PEER REVIEW COMMENTS

“INFRASOUND LEVELS NEAR WINDFARMS AND IN OTHER ENVIRONMENTS”

Issued by the South Australian EPA, dated January 2013

Figure 2 – G-weighting function

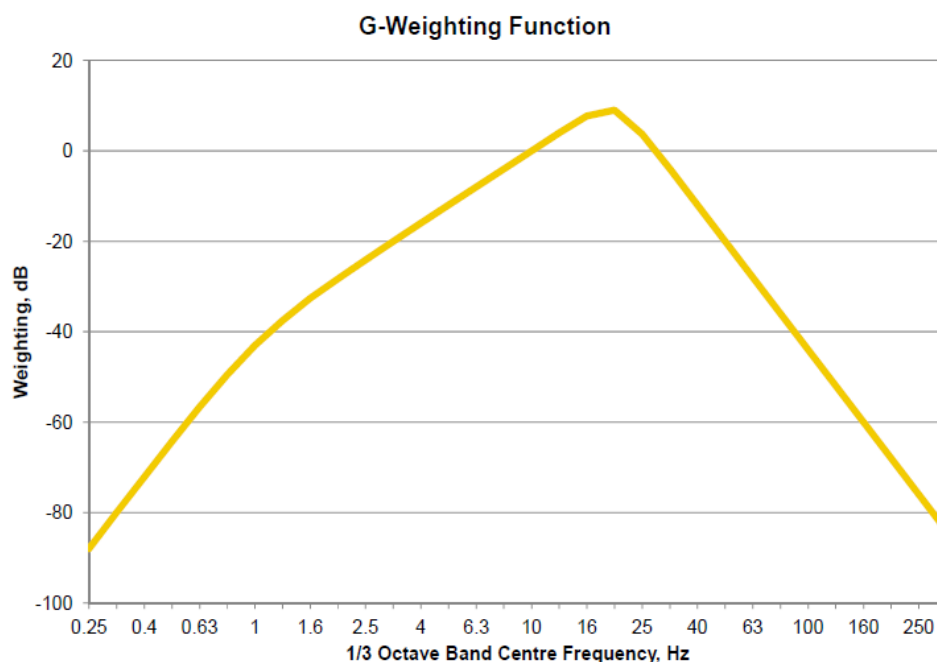
The authors claim in Section 2.1 that the dB(G) parameter covers the majority of the infrasound frequency associated with wind turbines, and then immediately provides a graph of the G-Weighting filter obtained from the ISO Standard 7196.

Immediately following the first paragraph of Section 2.1 a Figure is provided showing the weighting characteristics of the G-filter, and follows the procedure in the ISO Standard of referencing the attenuation with respect to a level of 0 dB at 10 Hz. The filter shows that there is amplification above the region of 10 Hz to 25 Hz, with a maximum of +9dB at 20 Hz.

Between 1 Hz and 20 Hz the filter drops off at 12 dB per octave whilst below 1 Hz and above 20Hz the filter drops off at 24 dB per octave.

At 6.3 Hz, being a typical lower limit of some sound level meters that can provide 1/3 octave band results, the dB(G) filter has a value of 8 dB below the reference level at 10 Hz. Similarly at a frequency of 1 Hz (that is typically near the blade pass frequency of modern day turbines) the filter exhibits a level of 43 dB below the 10 Hz 0 dB reference level.

Using dB level expressed in a Linear (Un-weighted) format, the frequency spectrum from modern day wind turbines is predominantly elevated in the 0.7 to 6 Hz region. It is therefore apparent to those appropriately trained in acoustics that the dB(G) value does not cover the majority of the infrasound region generated by turbines.

Figure 29 – Measured sound pressure levels with wind farm on and off, Bedroom 2 at house near Bluff Wind Farm

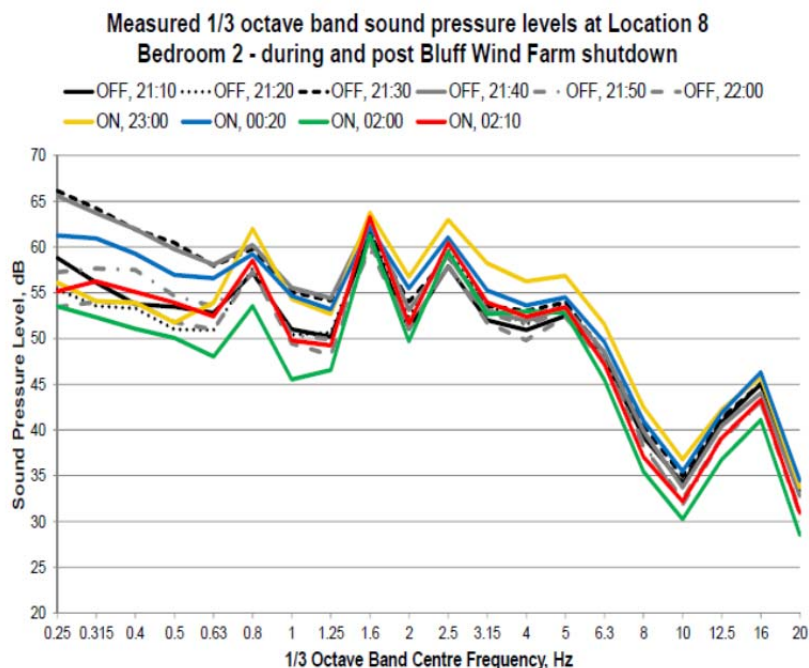
For example, later in the report (Figure 29) there is a 1/3 octave band spectrum chart limited to the frequency range of 0.25 Hz to 20 Hz that is reproduced below.

Examination of the above chart clearly indicates a significant degree of energy in the lower portion of the infrasound band. When it is superimposed with the dB(G) curve (Figure 2), it shows the claim as to the relevance of the dB(G) for infrasound noise from turbines to be incorrect.
